Property Information	Vanderpool Roofing Gateway Submission		
Address	117 Regional Park Dr. Kingsport, TN		
Tax Map, Group, Parcel	Tax Map 091A Group B Parcel 019.00		
Civil District	13 th Civil District		
Overlay District	Gateway District		
Land Use Designation	Industrial		
Acres	+/- 1.5		
Existing Use	Building Pad/Vacant	Existing Zoning	M-1R
Proposed Use	New Vanderpool Roofing Facility	Proposed Zoning	M-1R
Owner/ Applicant Information			
Name: Roger Barnett Address: 2400 N John B. Dennis Hwy., Suite 2 City: Kingsport State: TN Zip Code: 37617 Email: rbarnett@dbconstllc.com Phone Number: (423)-765-9517		Intent: <i>To receive gateway approval for a M-1R zone development for a new Vanderpool Roofing facility.</i>	
Planning Department Recommendation			
(Approve, Deny, or Defer) The Kingsport Planning Division recommends contingent gateway approval for the following reasons: • Civil Plans still need to be approved • The submitted plans conform to the Gateway standard. • The landscape specialist has approved the landscape plan • Staff is still in need of a lighting plan and dimensions of the proposed wall sign.

Site Plans Analysis

Site Plan

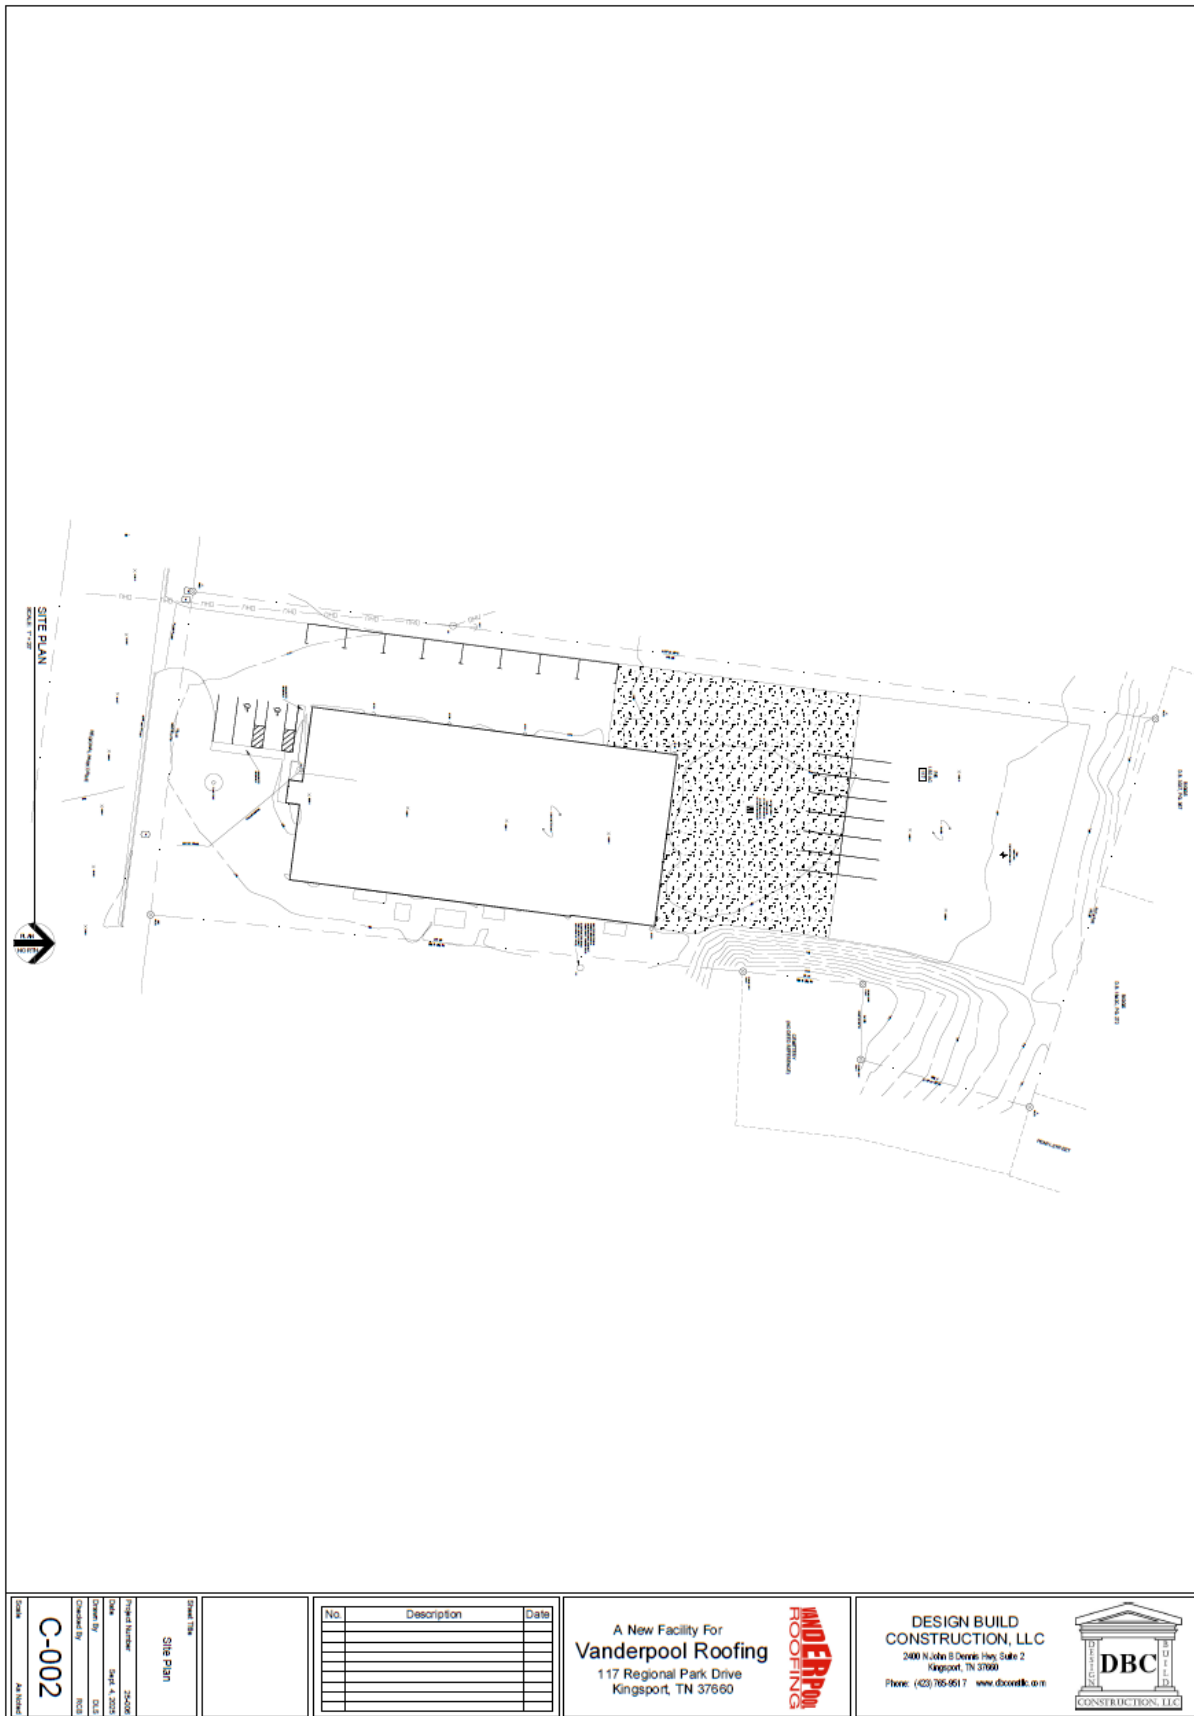
-
- No grading plan was required for this gateway submission.
 - Site Plan
 - The site plan notes that the power line will be routed underground from the existing above ground power pole. The site plan also displays the necessary amount of parking spaces required for this development.

- Lighting and utilities
 - Applicant will be providing an underground ditch for AEP to pull their electrical feed through, which is noted on the site plan. Additionally, the landscaping plan contains a note as well stating that all utilities shall be routed underground in compliance with City of Kingsport Gateway district requirements and standards.

Landscape Plan

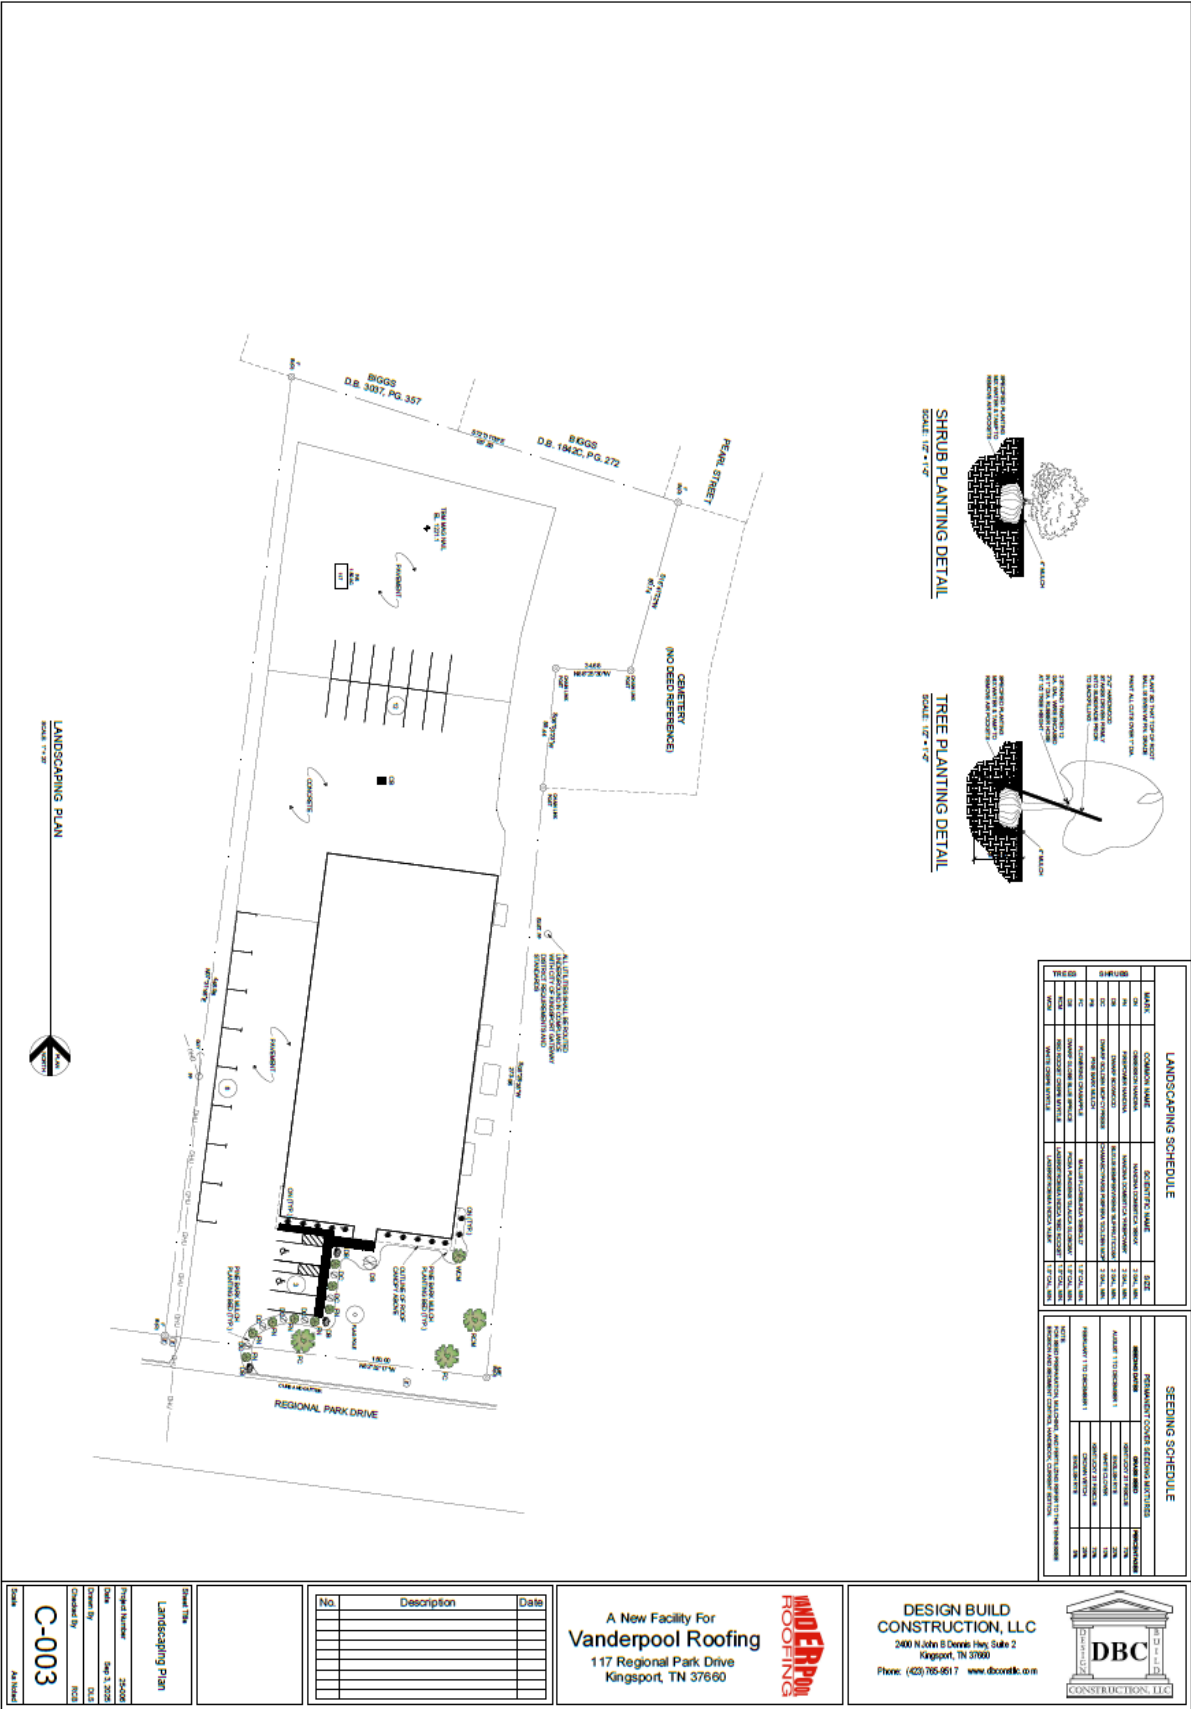
- Landscape Plan
 - The landscape specialist has given their approval for the proposed landscape plan.
 - Architectural Design
 - The materials being proposed for the building conform to the gateway standards. Materials proposed include: Corrugated metal siding and metal roof panels; pre-finished metal gutters, coping, and fascia and parapet; aluminum storefront windows with low emissivity insulated glass; 12'coiling steel overhead doors and hollow metal door frames.

Architectural Design

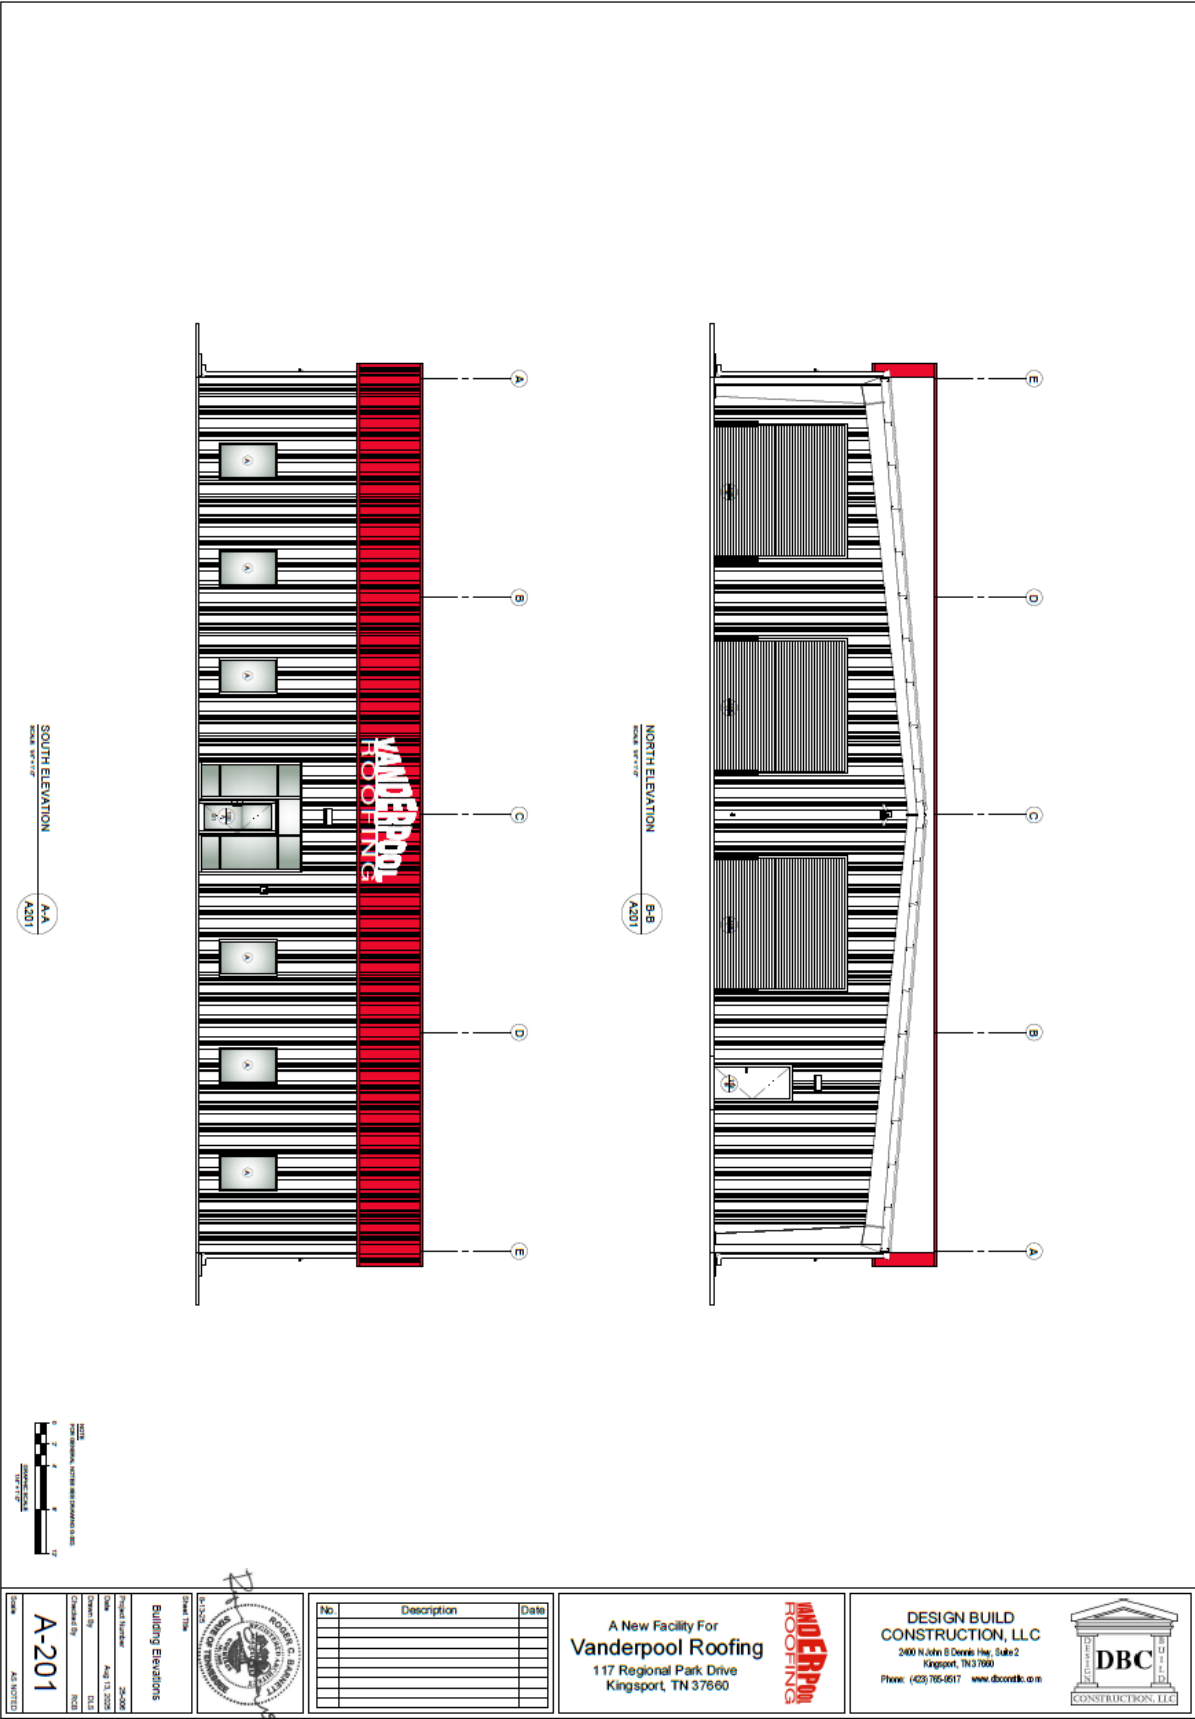
- The majority of the building consists of a neutral color in line with the gateway district standard. The red color displayed corresponds with the company's chosen branding color palate. Staff sees no issue with the inclusion of the red color being proposed for this development.
